City of El Paso – City Plan Commission Staff Report

Case No: SUSU14-00124 Fresno Place Replat A
Application Type: Resubdivision Combination
CPC Hearing Date: February 12, 2015
Staff Planner: Joaquin Rodriguez, (915) 212-1608
rodriguezjx3@elpasotexas.gov
Location: North of Yarbrough, West of Alameda
Acreage: 4.38
Rep District: 7
Existing Use: Residential
Existing Zoning: RF (Ranch Farm)
Proposed Zoning: RF (Ranch Farm)
Nearest Park: Thomas Manor Park (.7 mi)
Nearest School: Cadwallader Elementary (.1 mi)
Park Fees Required: \$4,110.00
Impact Fee Area: N/A
Property Owner: Damian Lara
Applicant: Damian Lara
Representative: Rey Engineering

ATTACHMENT 4

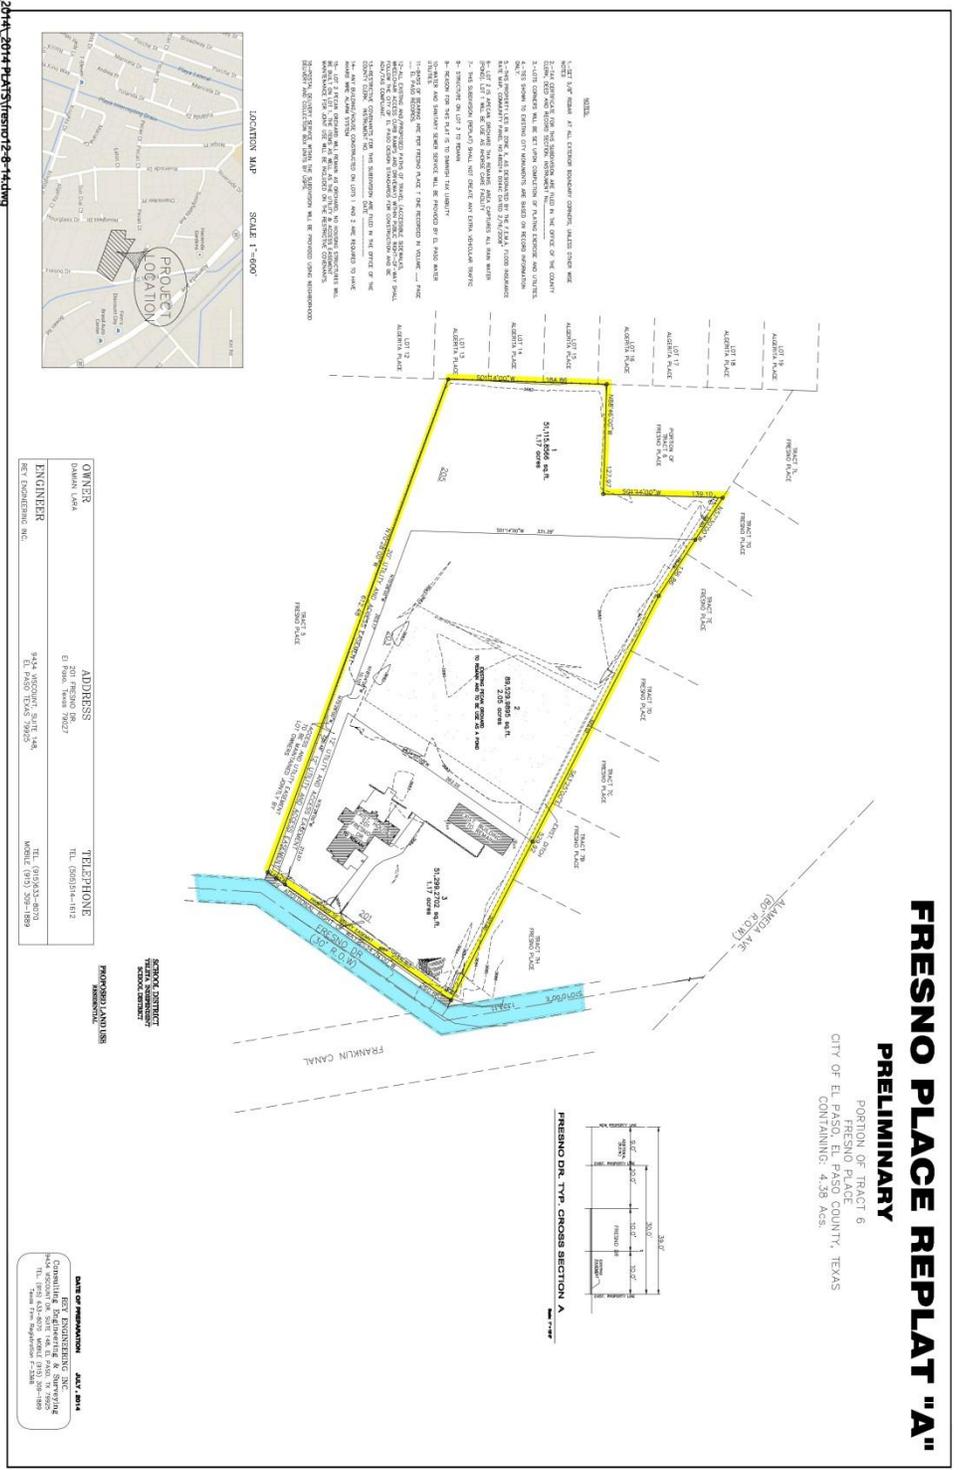
1. The engineer shall include an access easement for an offset turnaround at the end of the panhandle serving lot 1 in accordance with section 9.52.200.5 of the 2009 Fire Code.

1. The engineer shall include a note on the final recording plat and the subdivision improvement plans indicating whether buildings are required to be sprinklered within the subdivision, and which lot numbers have such requirement.
2. Deed restrictions for joint maintenance of the shared panhandle shall be recorded concurrently with the plat.

1. Add to general notes on preliminary and final plats: All storm water runoff shall be addressed within the subdivision limits and shall comply with all provisions of (DSC, 19.19.010A) and (DDM, 11.1).

1. EPWU does not object to this request.
2. Water and sanitary sewer service for the panhandle lots shall be provided at the property line adjacent to the public right-of-way. Extension of service (privately-owned service line) to each dwelling unit shall be the responsibility of the customer. Water service will be installed outside proposed driveway. No vehicular traffic is allowed over the water meter boxes.

EPFD recommends **approval** subject to plat illustrating conformance with Section 19.23.040 of the Subdivision code. The following need to be noted on the Plat.

Per Requirements of the 2009 Fire Code D103.4 Dead ends. Dead-end fire apparatus access roads in excess of 250 feet (76.2 m) shall be provided with width and turnaround-provisions in accordance with Table D103.4 Dead ends 9.52.200.5.
